City of El Paso – City Plan Commission Staff Report

Case No:	SUSU16-00017 Tierra Del Este Unit 81
Application Type:	Major Preliminary
CPC Hearing Date:	May 19, 2016
Staff Planner:	Vanessa Munoz, (915) 212-1644, munozvx@elpasotexas.gov
Location:	South of Pebble Hills and East of John Hayes
Acreage:	182.026
Rep District:	ETJ (Adjacent to District 5)
Existing Use:	Vacant
Existing Zoning:	ETJ
Proposed Zoning:	R-5
Nearest Park:	Linear Parks proposed within subdivision
Nearest School:	Pebble Hills High School (0.65 miles)
Park Fees Required:	N/A
Impact Fee Area:	Eastside Impact Fee Service Area
Property Owners:	Ranchos Real XV, LLC
Applicant:	Ranchos Real XV, LLC
Representative:	Conde Inc.

ATTACHMENT 3

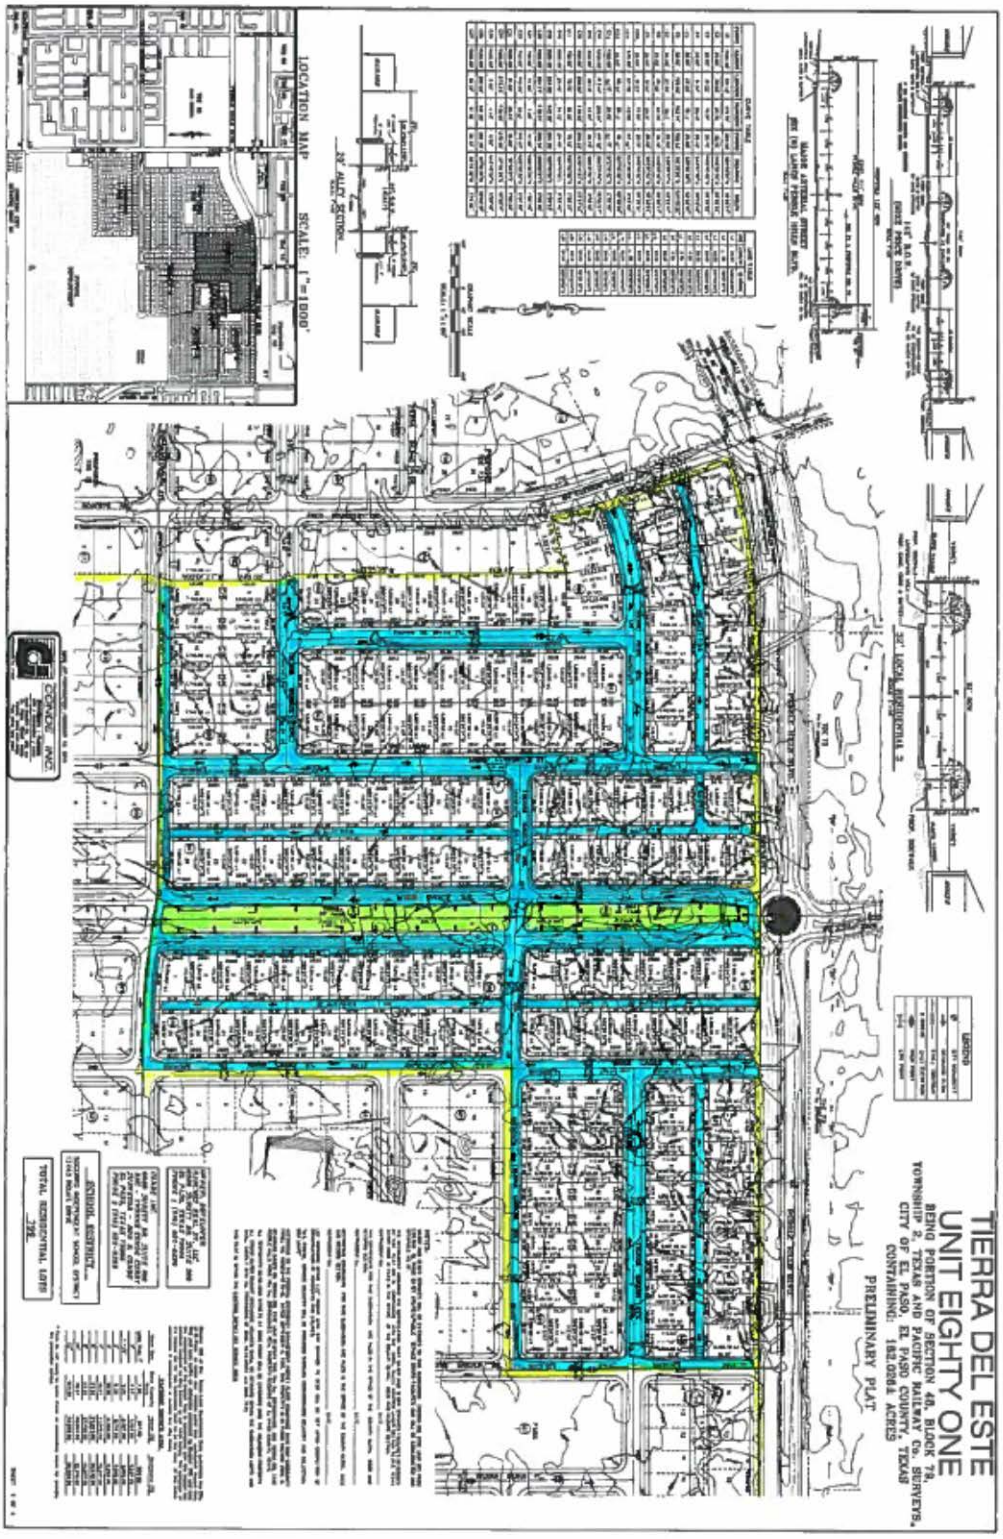
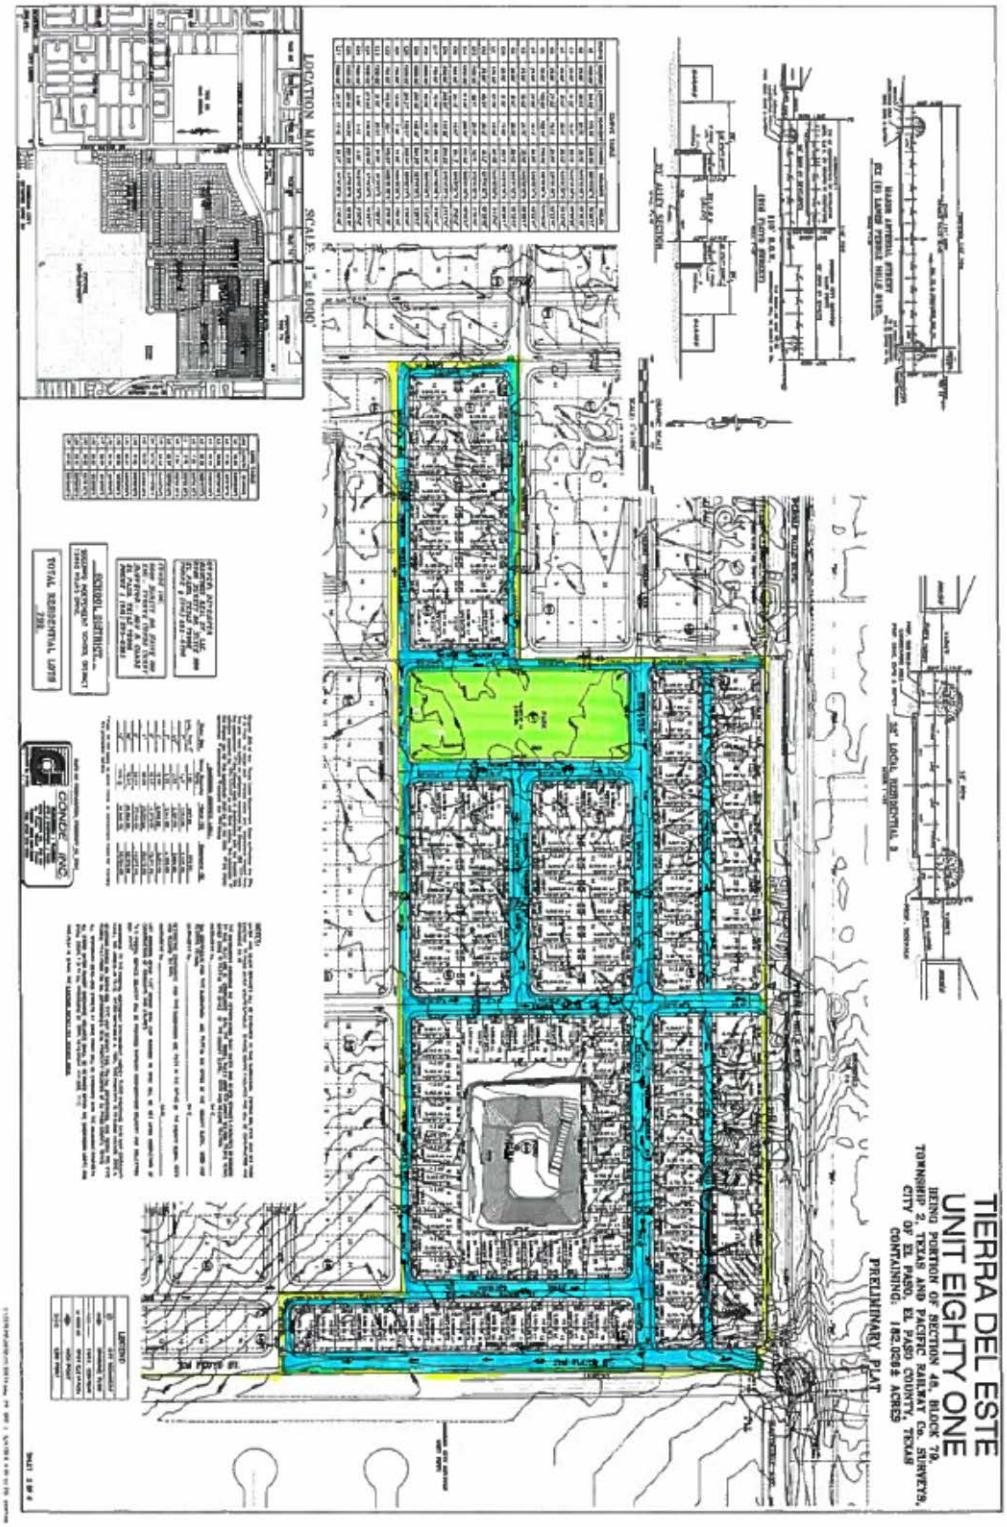
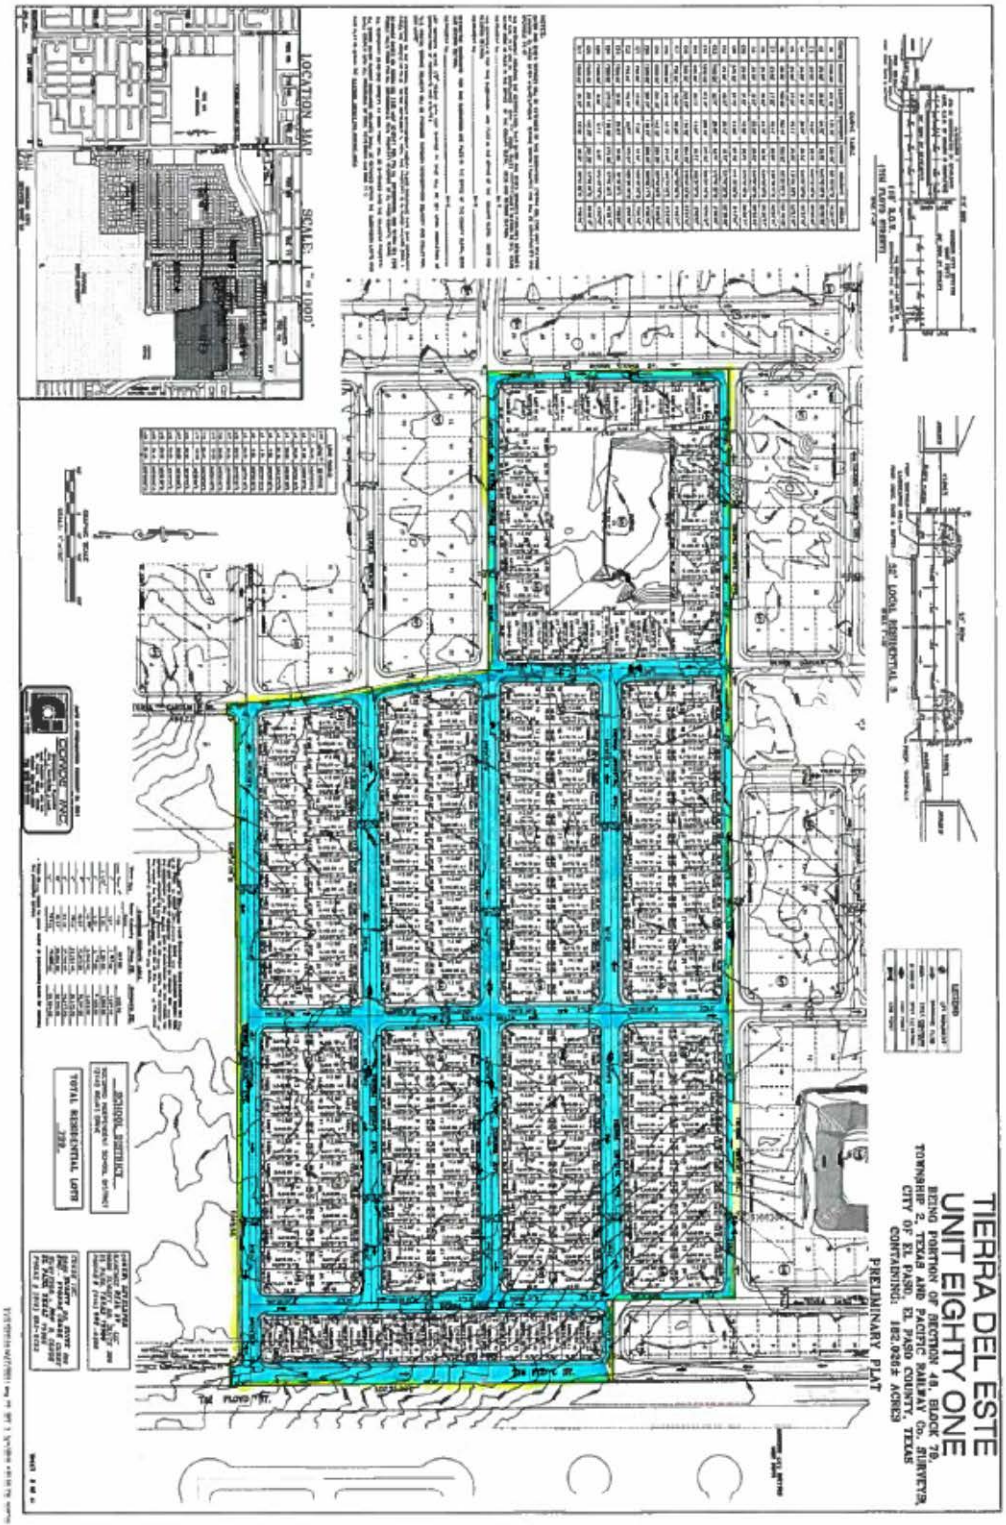
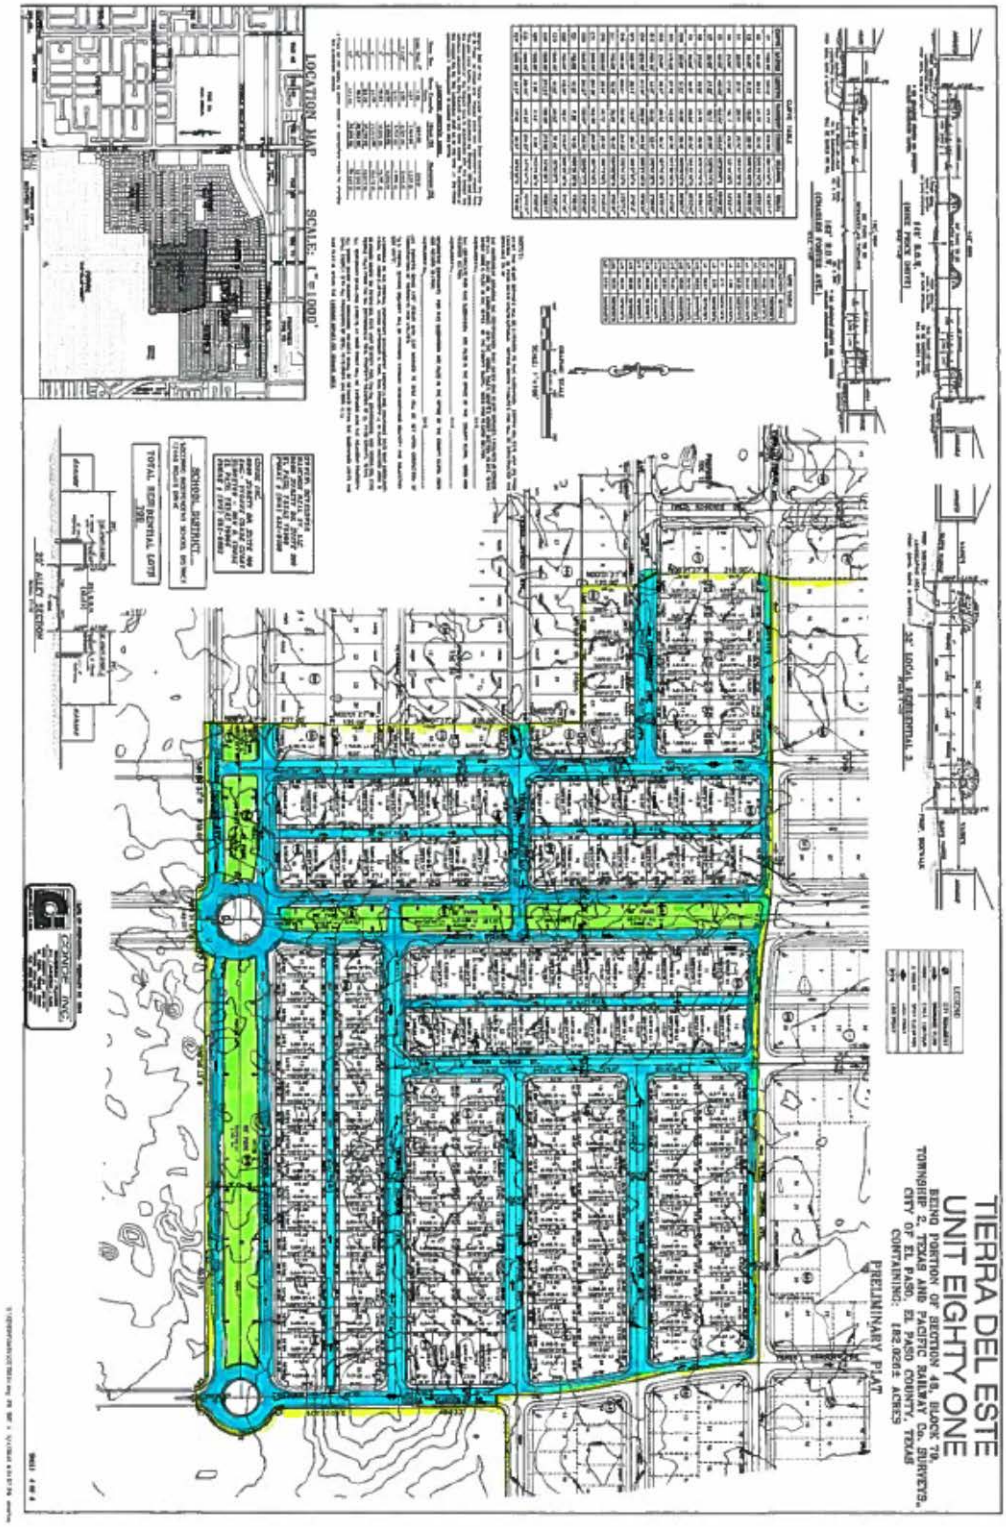
1. Add note to preliminary and final plat sheets: "All storm water runoff discharge volumes shall be retained within the subdivision limits and shall comply with all provisions of (DSC, 19.19.010A and DDM, 11.1)."

2. As per section (Code 19.08.010, Section D), each proposed phase of development shall have a complete drainage system, or security for all improvements that are not completed in the initial phase is provided.

3. Run-off flowing from street ROW into undeveloped terrain must do so through a temporary

catch basin to avoid erosion of the street or terrain.

4. Show the drainage flow patterns within the 20' alleys.

5. The park does not show any drainage flow pattern; need to clarify if the park will retain its own run-off or will it discharge it into the street.

1. Submit to the Planning and Inspections Department – Planning Division the following prior to recording of the subdivision.
    a. Current certified tax certificate(s)
    b. Current proof of ownership
    c. Release of access document, if applicable
    d. Set of restrictive covenants, if applicable
2. Every subdivision shall provide for postal delivery service. The subdivider shall coordinate the installation and construction with the United States Postal Service in determining the type of delivery service for the proposed subdivision. In all cases, the type and location of delivery service shall be subject to the approval of the United States Postal Service.
3. Add square footage to Lot 22, Block 524.
4. Remove "City of El Paso" from legal description.
